**Re-evaluation
of the
Final Environmental Impact Statement
US 93
Evaro to Polson**

Re-evaluation of Final Environmental Impact Statement
And Section 4(f) Evaluation Approved on 6/17/96

F 5-1(9)6 U.S. Highway 93, Evaro – Polson
Missoula and Lake Counties, Montana

Figure 6 Ravalli Hill

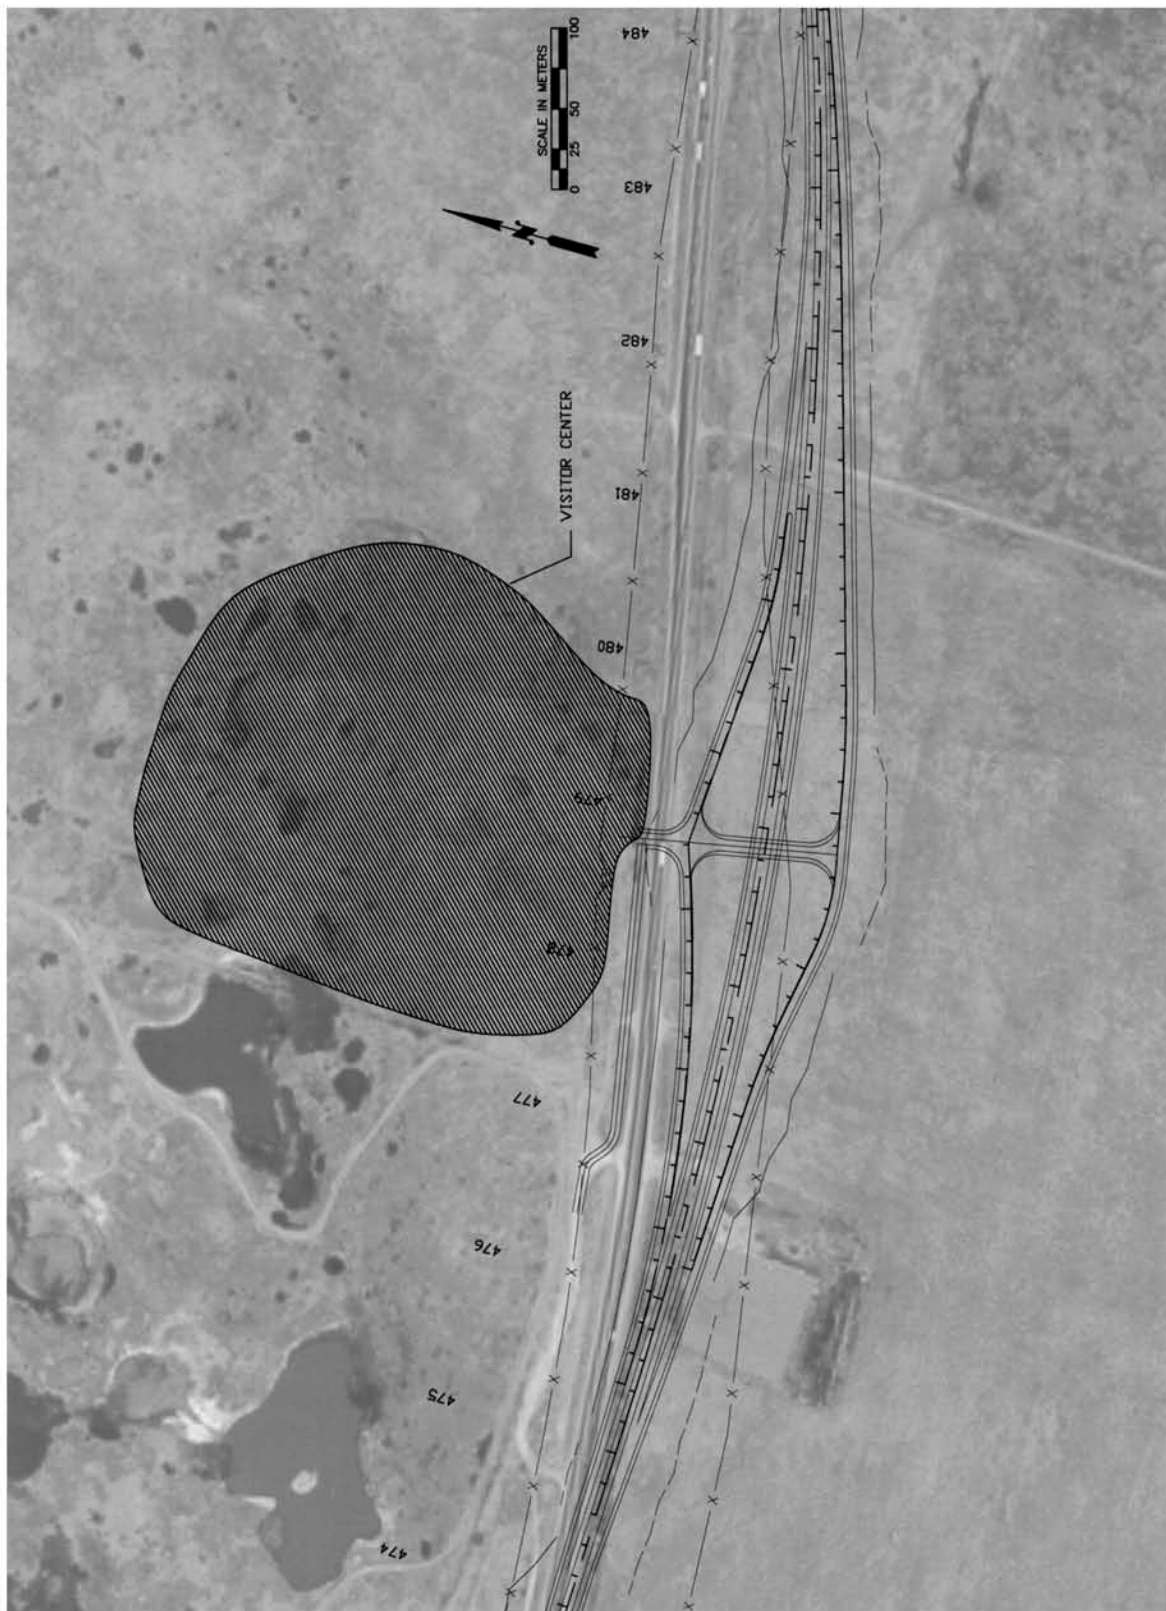
to the south and provide access with an interchange to allow the roadway geometry to provide a more natural entrance to the Visitor Center and avoid all impacts to the Bison Range, a Section 4(f) resource. It also proposed building the new Visitor Center on the north side of the highway and reclaiming the site of the existing Visitor Center on the south side.

Figure 9 Glory Road

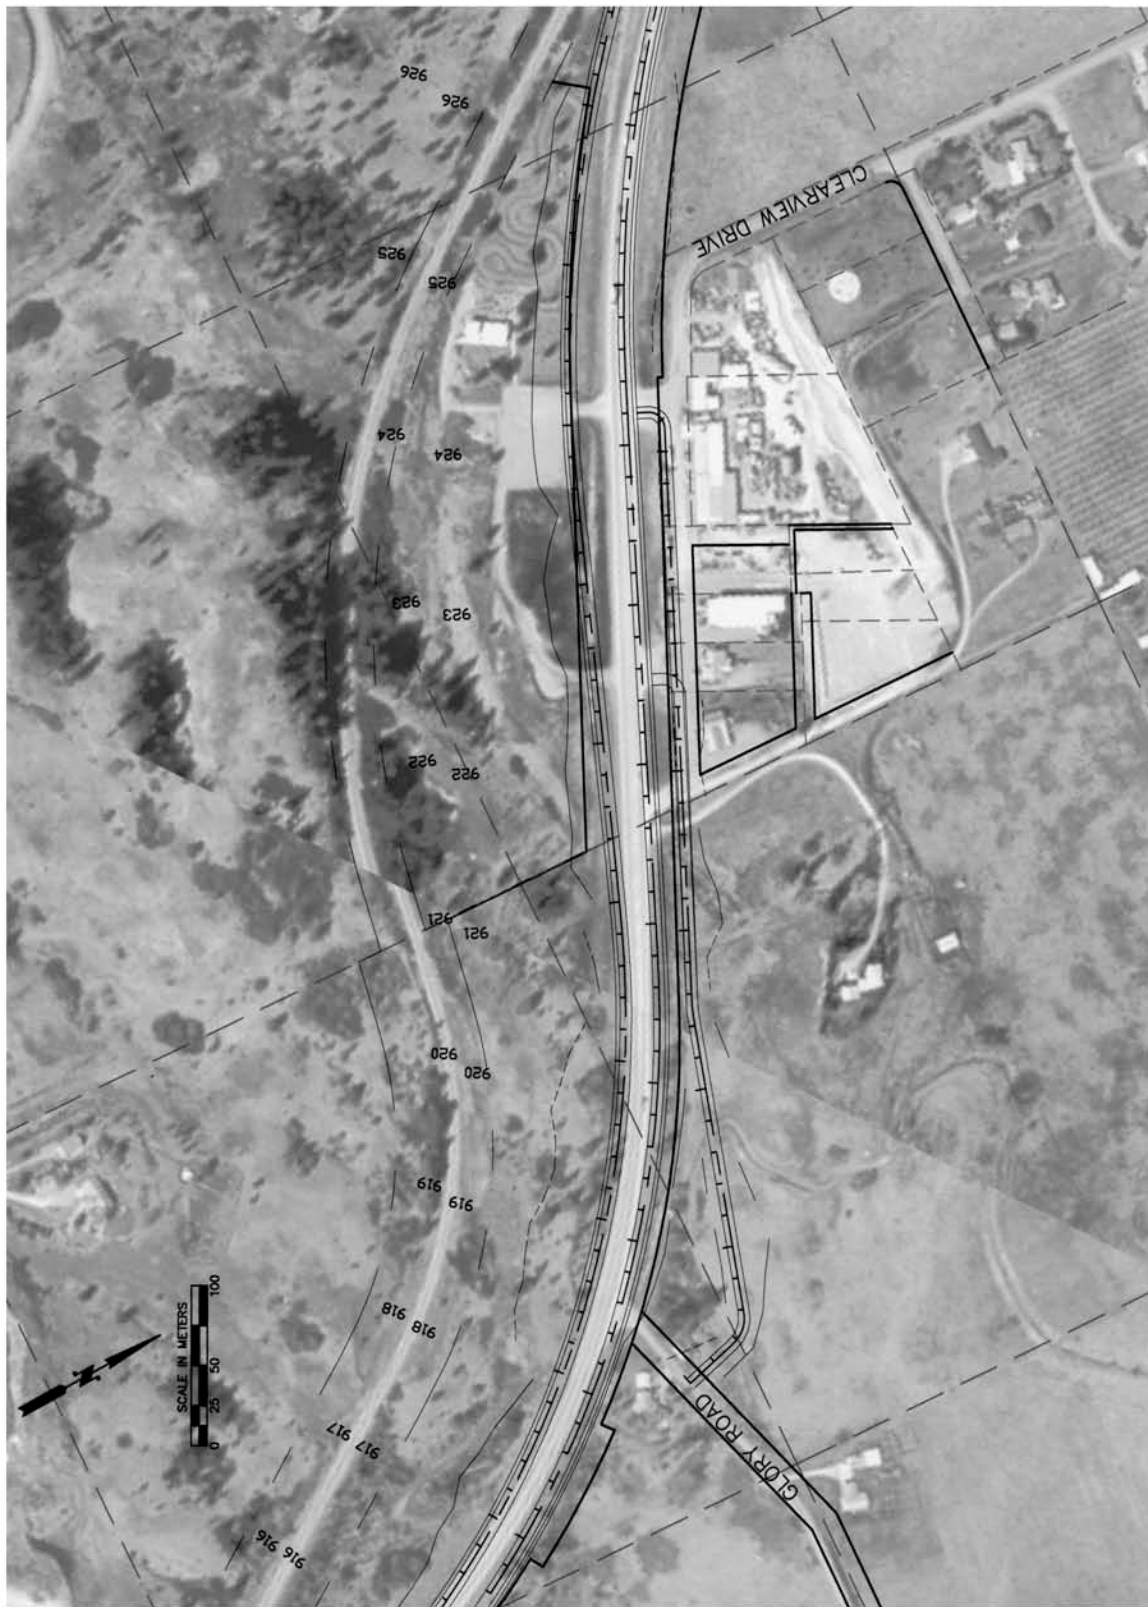
~~To alleviate the large cuts to the natural vegetated hillside to the west of US 93 in this area, the frontage road to Glory Road was relocated to the bottom of the slope east of US 93. The frontage road was planned to intersect US 93 at the south edge of the James R. and Sue Anne Iman parcel, impacting about half of their frontage on US 93. It crossed the front of the Nickel Cars used car lot, impacting much of their display and access areas. It then followed the bottom of the fill slope for US 93 for approximately 300 meters, and swung east to tie into Glory Road about 100 meters east of US 93. By moving the frontage road to the toe of slope the impact on the property owners in that area is minimized.~~

~~Due to the impacts of the frontage road on the parking of the businesses as well as the display for Nickel Cars, the three governments agreed to move the frontage road connection to US 93 to the south end of the Nickel Cars property. The accesses to Nickel Cars and the private residences just south of there will connect to the frontage road. Two other commercial accesses will be provided as shown in the Access Control and Corridor Preservation plans, one to be shared by Les Schwab Tires and the Iman property, and the other for the Museum and Clearview Drive. Details for median crossings will be worked out during the design phase.~~
